# Application Bulletin AB-10

## Substituting the RC5051 for the RC5050

Figure 1. RC5050 and RC5051 Application Differences

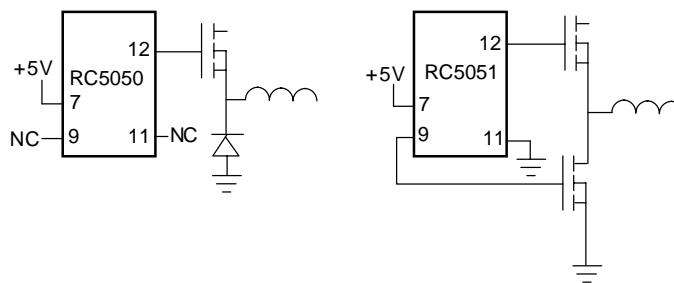
The RC5050 and the RC5051 are both programmable DC-DC controllers for low voltage microprocessors. Their only functional difference in an application is that the RC5051 is designed to run a synchronous rectifier in place of the RC5050's freewheeling diode (see Figure 1).

In the RC5050, pin 9 is not connected, whereas in the RC5051 it drives the gate of the synchronous MOSFET rectifier. In the RC5050, pin 11 is not connected, whereas in the RC5051 it is a power ground. Finally, in the RC5050, pin 7 powers the internal digital logic from +5V, whereas in the RC5051 it powers the synchronous MOSFET's gate driver.

**If neither pin 9 nor pin 11 has a trace going to it, the RC5051 may be substituted for the RC5050. If pin 9 has no trace going to it, and pin 11 is attached to power ground (NOT signal ground), the RC5051 may be substituted for the RC5050. Other than in these two cases, the the RC5051 should NOT be substituted for the RC5050.**
